**STAFF RECOMMENDATION**  
**1322 6<sup>th</sup> Avenue North**  
**May 18, 2016**

**Application:** New construction – infill  
**District:** Germantown Historic Preservation Zoning Overlay  
**Council District:** 19  
**Map and Parcel Number:** 08209005400  
**Applicant:** Patrick Bales, Architect  
**Project Lead:** Sean Alexander, sean.alexander@nashville.gov

**Description of Project:** The applicant is proposing to construct a new one-story commercial building on vacant land between two historic buildings. This application is a revision of a proposal that was denied at the previous public hearing.

① SITE PLAN  
1" = 30'-0"

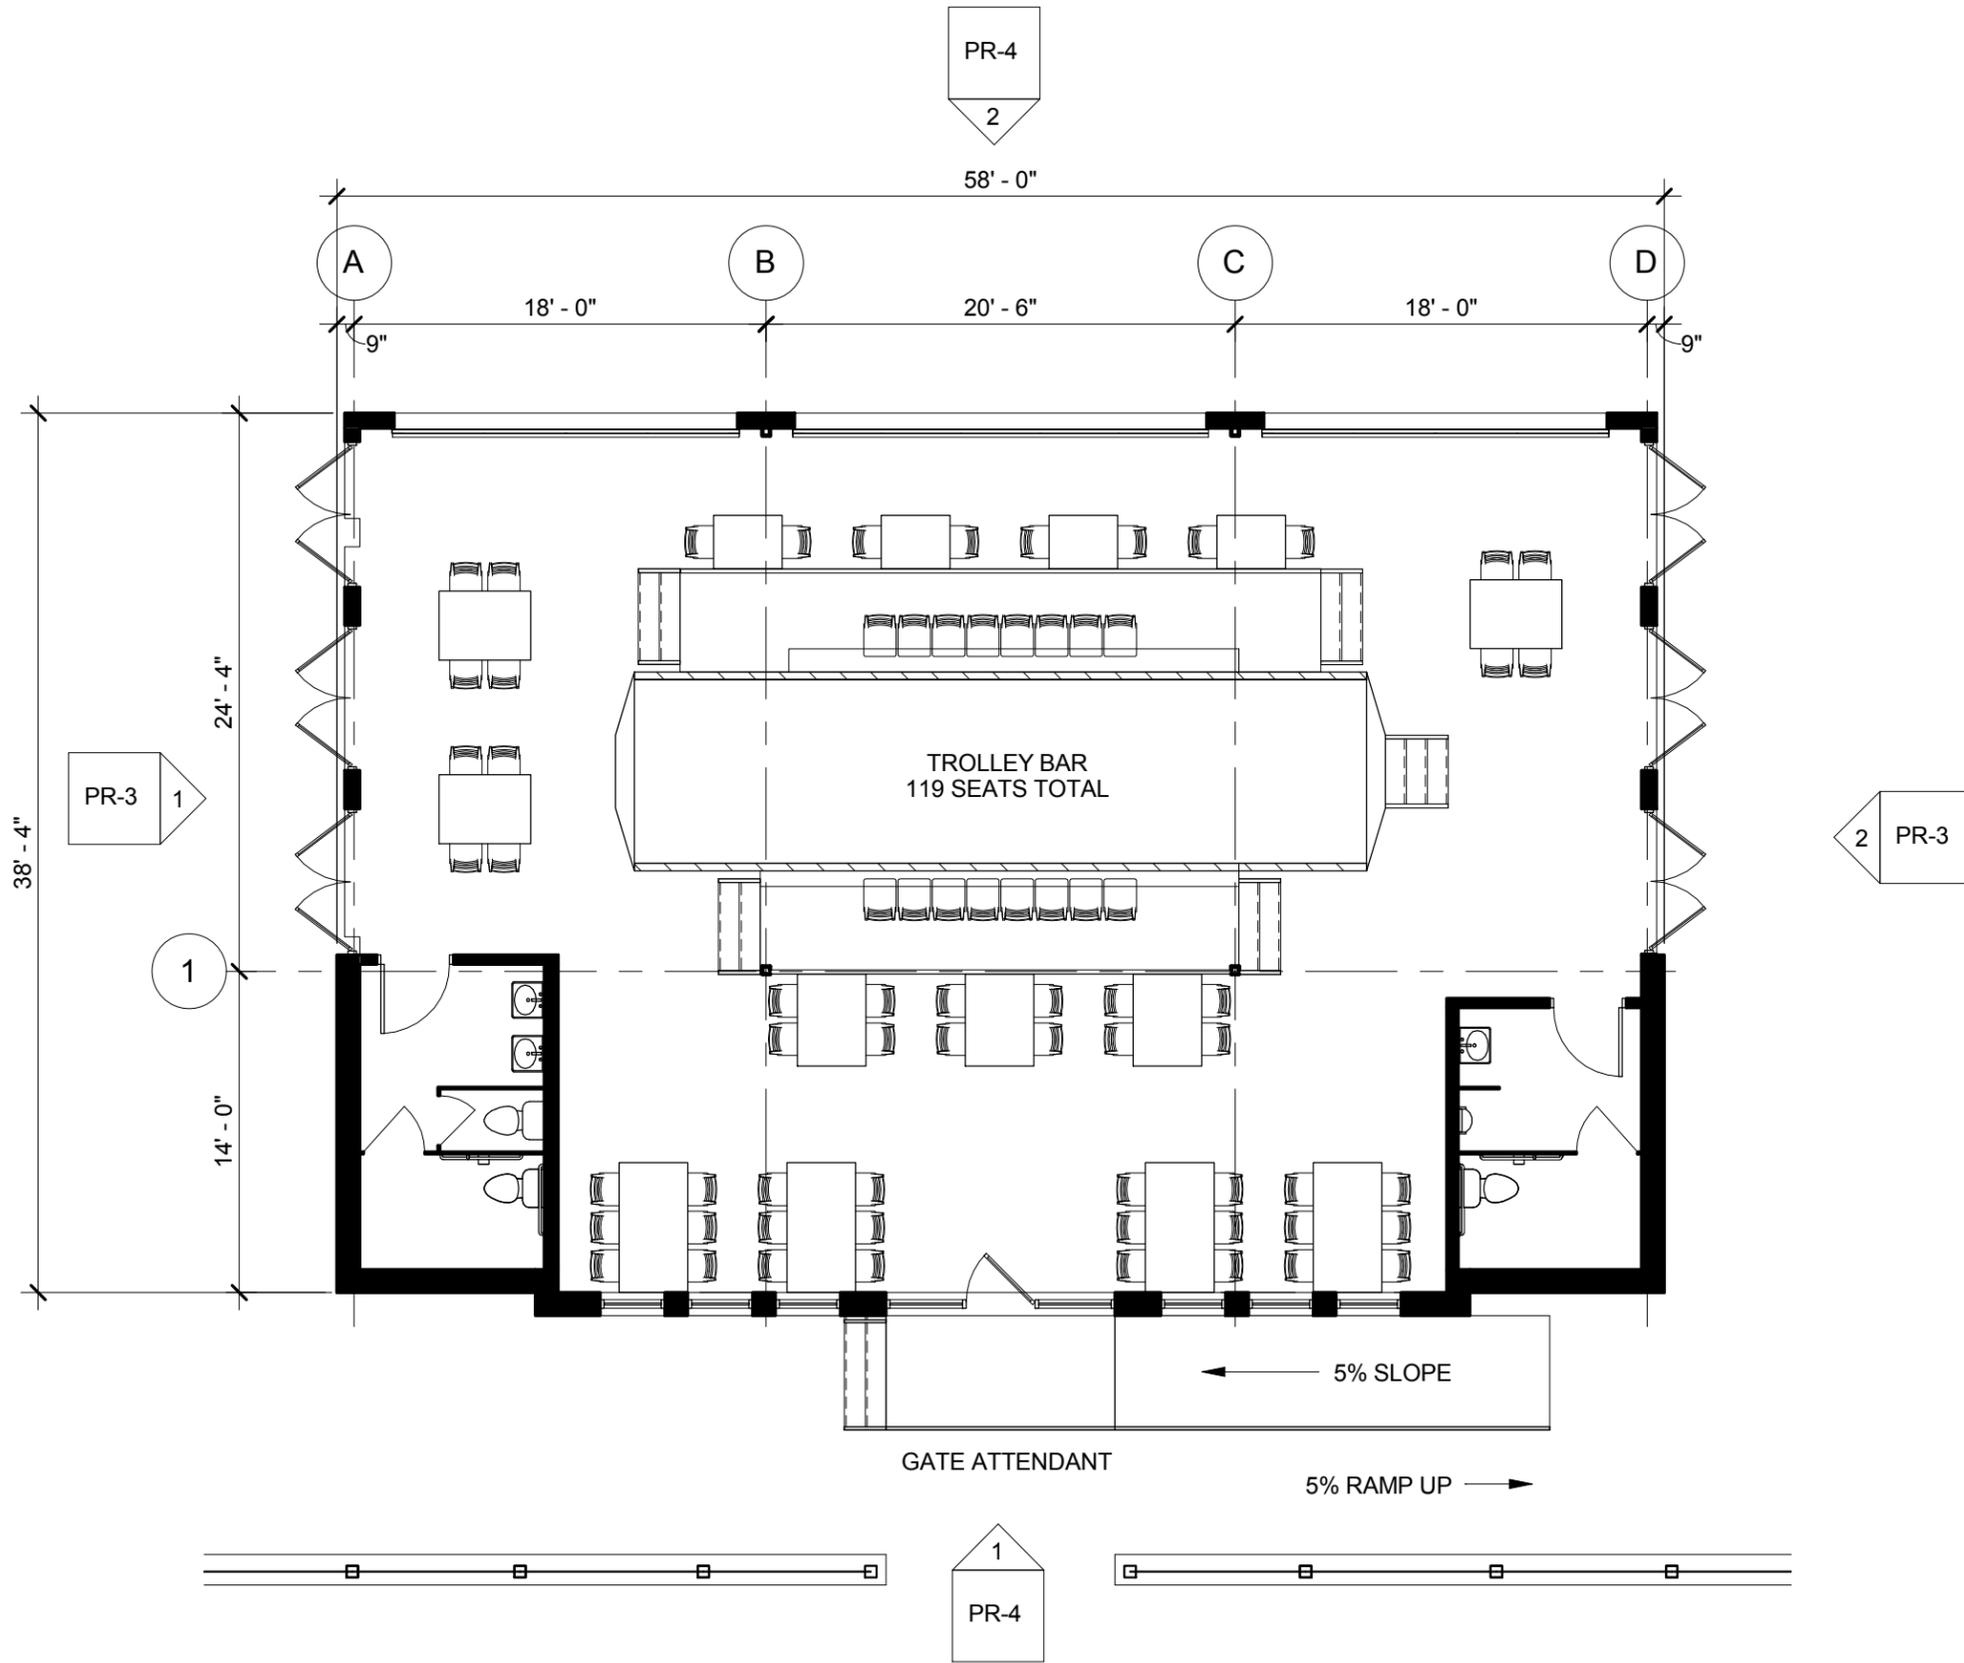
Site Features, Appurtenances: New walkways, railings, a fountain, and fences will be installed on the lot. The materials of these items are not known at this time, therefore Staff recommends that administrative review of those items be required as a condition of approval. The plans show an electrical transformer box located in the front-right corner of the lot. Staff recommends that the transformer box be located at the rear of the lot. As conditions of approval, staff recommends that conditions are added requiring that the electrical transformer box shall be located at the rear of the lot, and that more information on these appurtenances that shall be administratively reviewed prior to permitting to

ensure that the meet guideline 5.1 and 5.2, and that the electrical transformer box is located at the rear of the lot.

The project will retain portions of an existing parking lot at the rear of the property, accessed by an existing driveway to the right of the building at 1318 and the alley. Staff recommends reducing the width of the driveway curb-cut to twelve feet (12’), which would be more typical of the widths of other nearby driveways. This lot will be shared by the new building and the two adjacent buildings, with entrances from 6<sup>th</sup> Avenue North at an existing curb cut and the alley to the rear. Staff finds the parking lot design to meet section 5.3 of the design guidelines.

① SIDE ELEVATION  
1/8" = 1'-0"

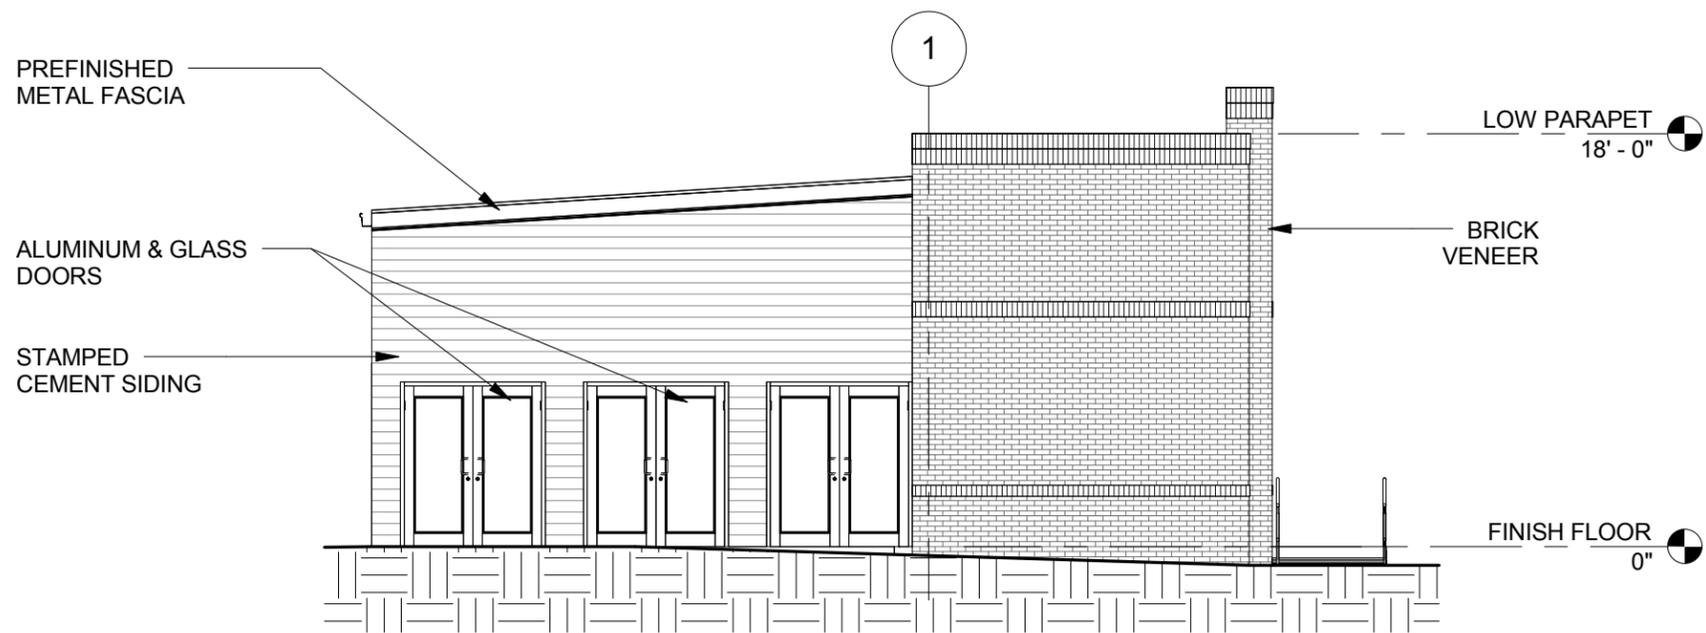
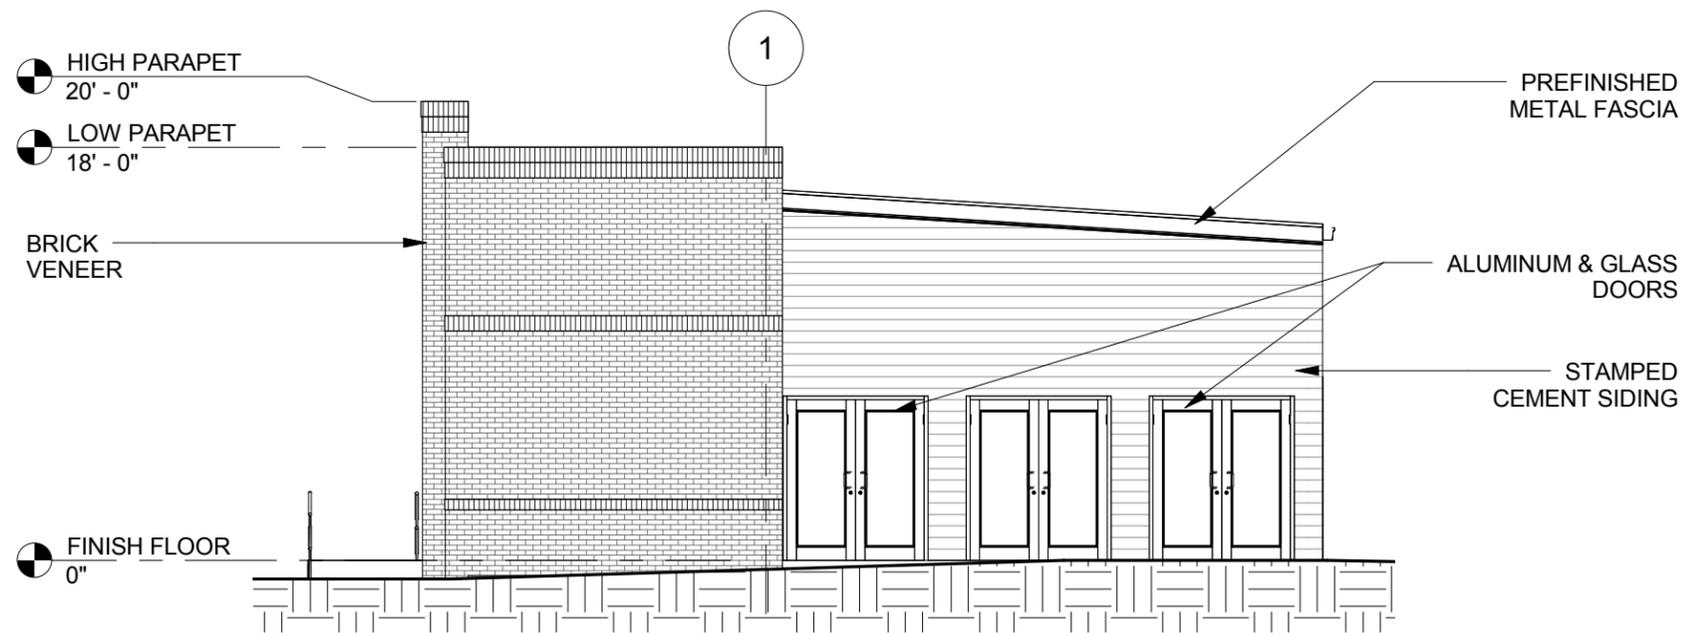
Walls/Exterior Materials: The primary exterior materials on the new building will include brick on the front façade, continuing on the sides approximately one third of the depth of the building before switching to cement-fiber clapboard siding. Whereas the plans show “stamped siding,” siding in the historic neighborhood typically is smooth. Both of these materials are appropriate for new construction when the brick is traditional in its color and texture, and the cement-fiber siding has a smooth surface with an exposure no greater than five inches (5”). Staff also asks that any exposed corner between two clapboard-sided walls have a four inch cornerboards, as is typical of historic buildings. With the conditions that Staff shall approve the masonry and siding selections and that cornerboards are added, Staff finds that the infill meets guidelines 2.4.1, 2.4.5, and 2.4.6.

The side facades of the building will each have sets of double glass doors. The side doors are vertically oriented, which is consistent with the proportions of windows on historic buildings in the area.

① FRONT ELEVATION  
1/8" = 1'-0"

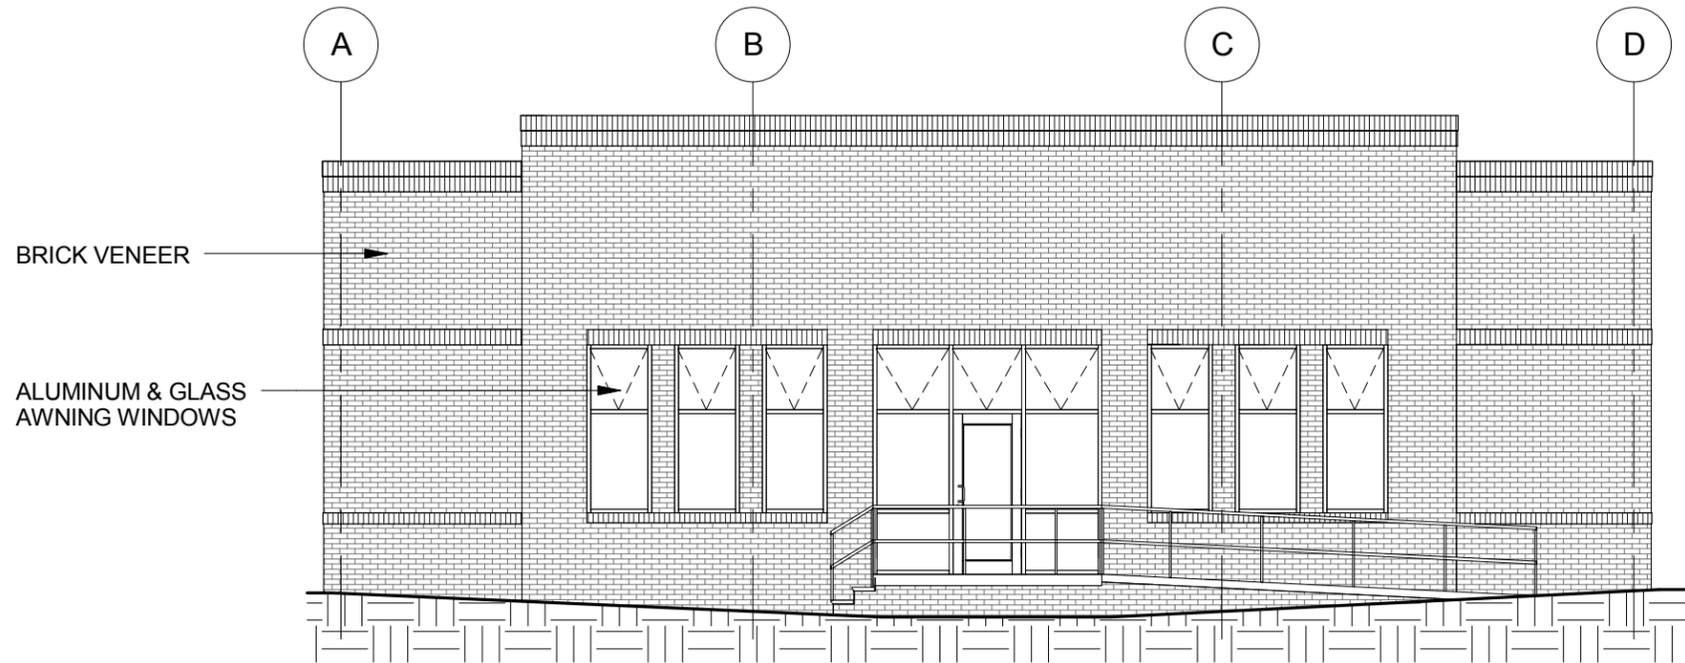
The front facade of the new building will be symmetrical with five distinct bays. In the center of the building will be a main entrance, with a trio of windows in the bays to either side. Together these three bays will be forty feet (40') wide. This center section of the building will be flanked by a pair of shorter windowless walls, set one foot (1') back from the front wall. These bays will bring the total width of the building to fifty-eight feet (58') wide.

Windows & Doors: As with the previous design, the front façade of the building will have a central doorway with transoms and sidelights. Staff finds the configuration and

location of this primary entrance to be appropriate. The new front doors will be narrow and tall, will be all glass, and will be recessed four inches (4") from the primary wall. The windows on the front façade will be storefront-type windows, and they will also be narrow and tall and recessed four inches (4") from the primary wall.

Porches, Entrances: The primary facade of the new building will face 6<sup>th</sup> Avenue North directly, with an entrance in the center of three bays. There will be a stoop at the entrance, from which Staff recommends that a walkway shall be added leading to the front edge of the property to engage the right of way in a manner consistent with historic buildings nearby. With the condition that a walkway shall be added from the front stoop to the sidewalk, Staff finds that the proposed infill would meet sections 2.6.1 and 2.6.2 of the design guidelines.

Roof: The roof of the building will be flat with a stepped parapet on the front facade of the building, as seen on many historic buildings in the district. Staff finds that the project will meet sections 2.7.1 and 2.7.3 of the design guidelines.

② REAR ELEVATION  
1/8" = 1'-0"

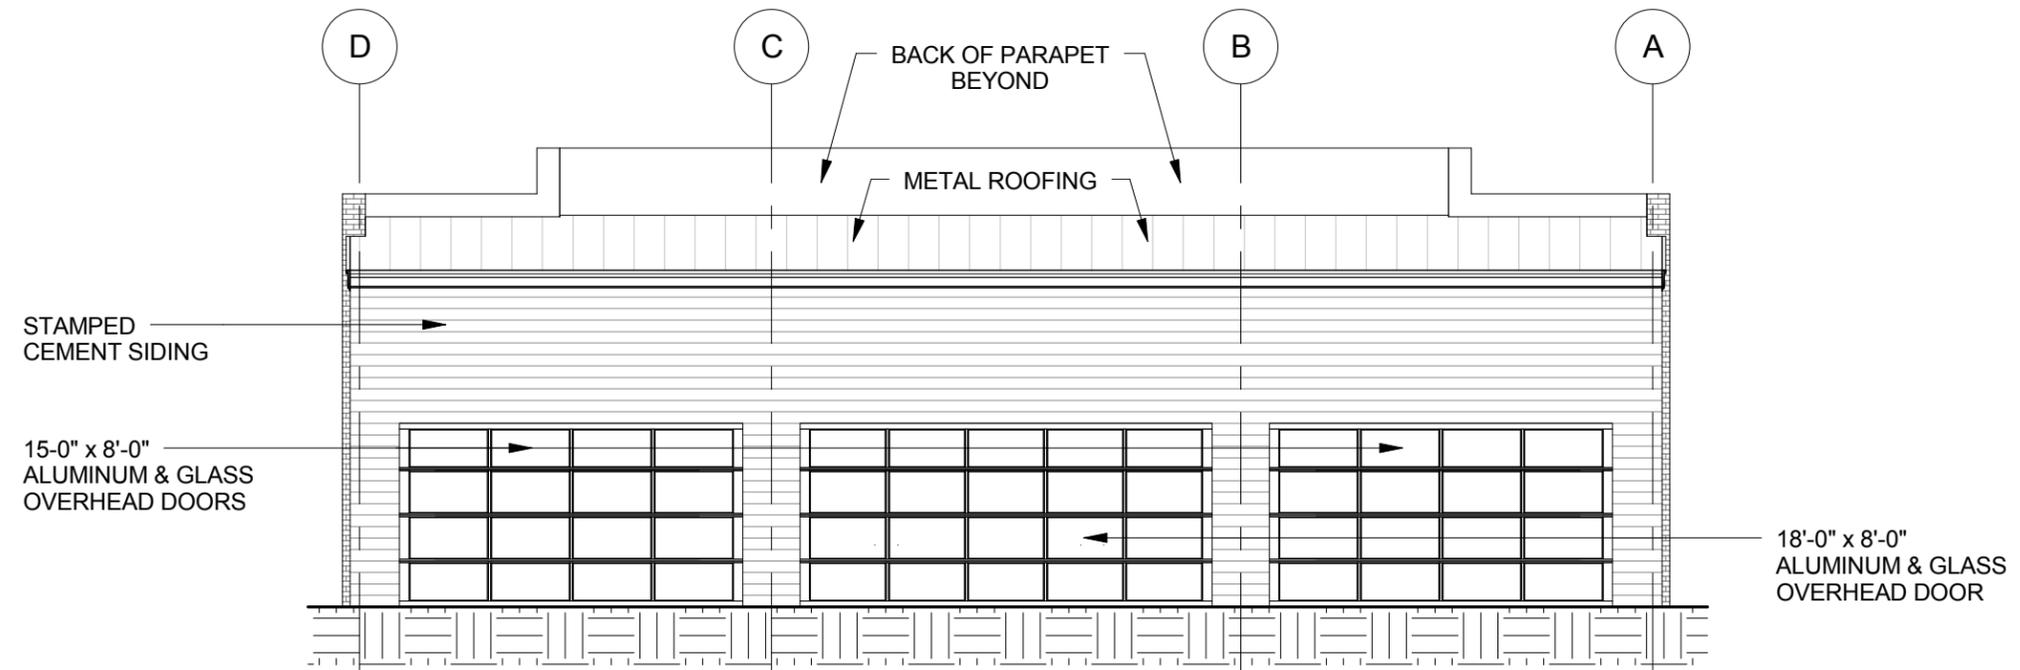
The rear elevation will have overhead doors. The doors on the rear cannot be seen from 6<sup>th</sup> Avenue North, and do not have an impact on the historic character of the area. Under section 2.1.1 of the design guidelines "*Facades facing the alley are generally not considered public facades.*" The rear wall/doors will be screened from the alley by an eight foot (8') tall decorative privacy fence. Additional information is needed regarding the design of the fence. (See "materials.")
